E8364A-03

S E R V I C E N O T E

E8364A PNA Microwave Network Analyzers

December 2, 2005

Figure 1: A3 Front Panel Interface Board Assy without the Bracket

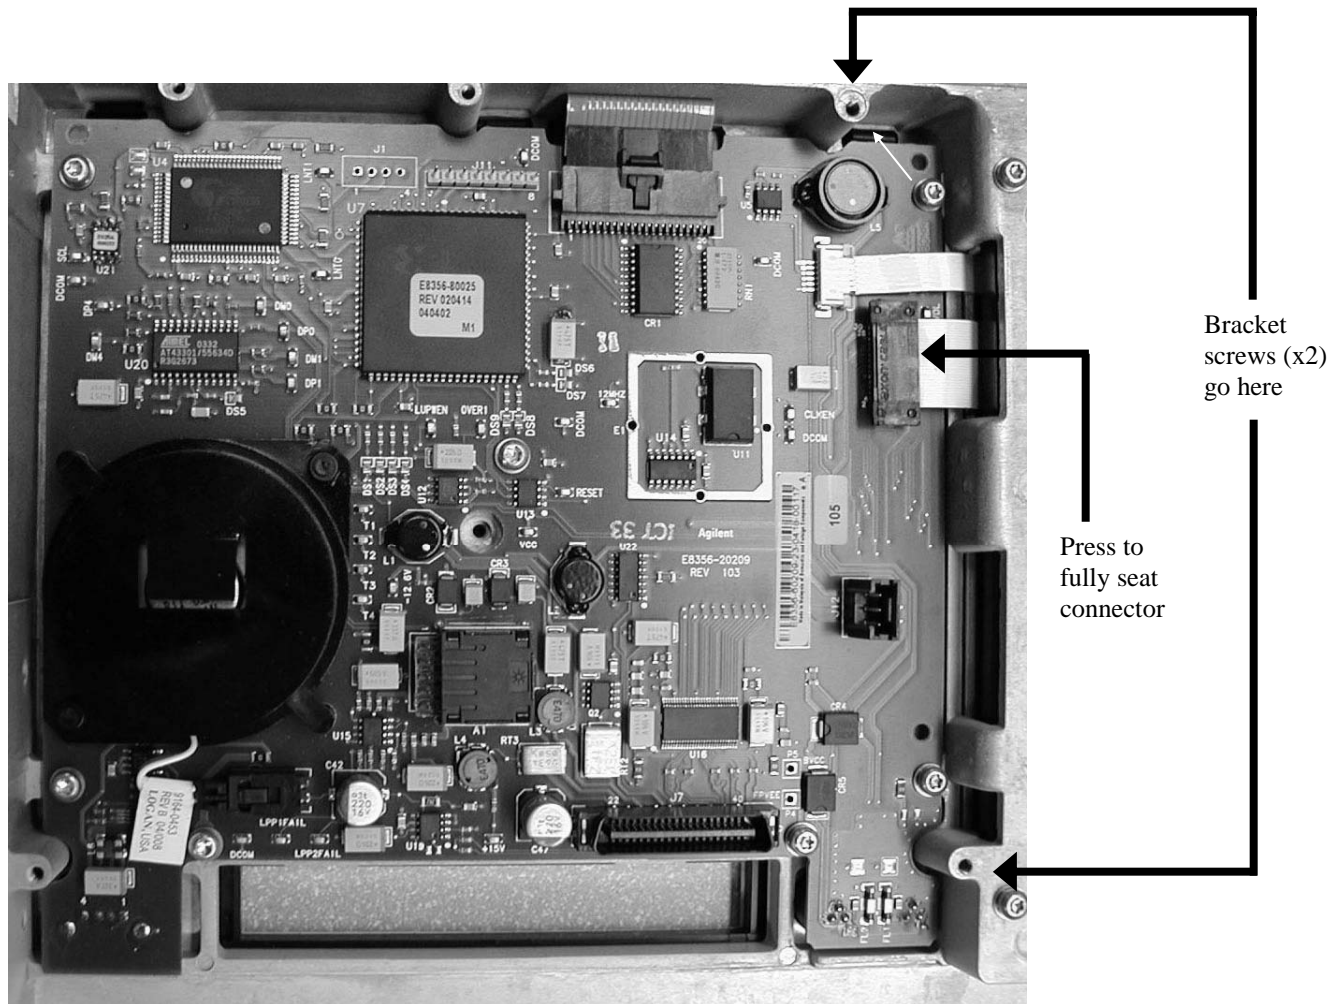
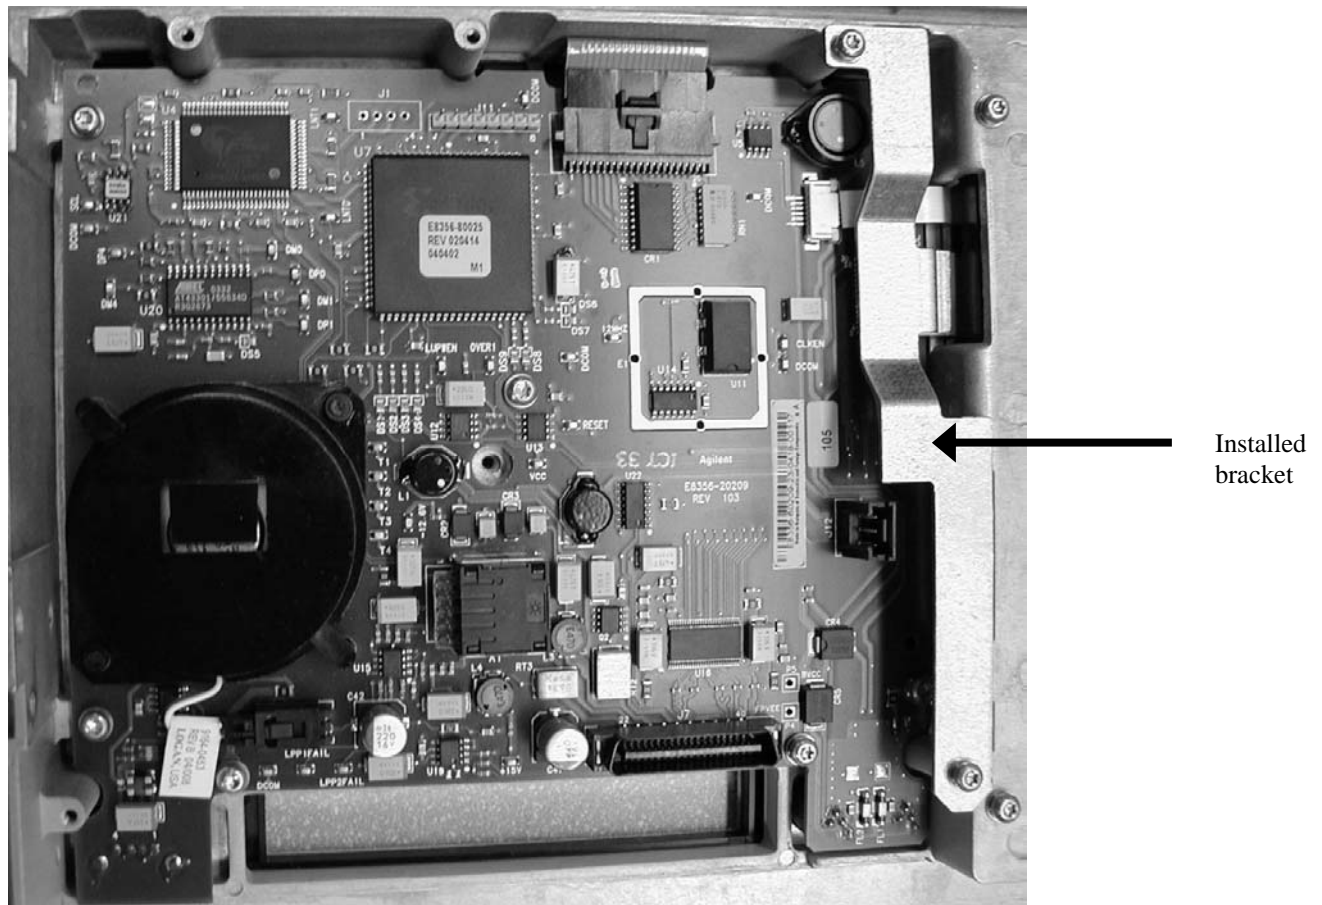
A connector of the ribbon cable (Agilent part number 8120-8409) that joins the front panel display to the front panel interface board can loosen, causing a display failure, unless a new bracket is installed. Because the failure rate has been very low, it is recommended that the bracket be installed only when there is an additional reason to remove the PNA front panel.

1. Refer to Figure 1 in this document:
 - Press down firmly on the ribbon cable's black connector.
 - Locate the two tapped holes for the bracket screws.
2. As shown in Figure 2 in this document, position the bracket so that its holes line-up with the two holes you located in the previous step.
3. Hand-start the two screws, and then torque both to 9 in-lbs.
4. Reinstall the PNA Front Panel by following the Service Guide instructions in the "Replacement Procedure." This is located on the same page as the "Removal Procedure" used previously in step 7.
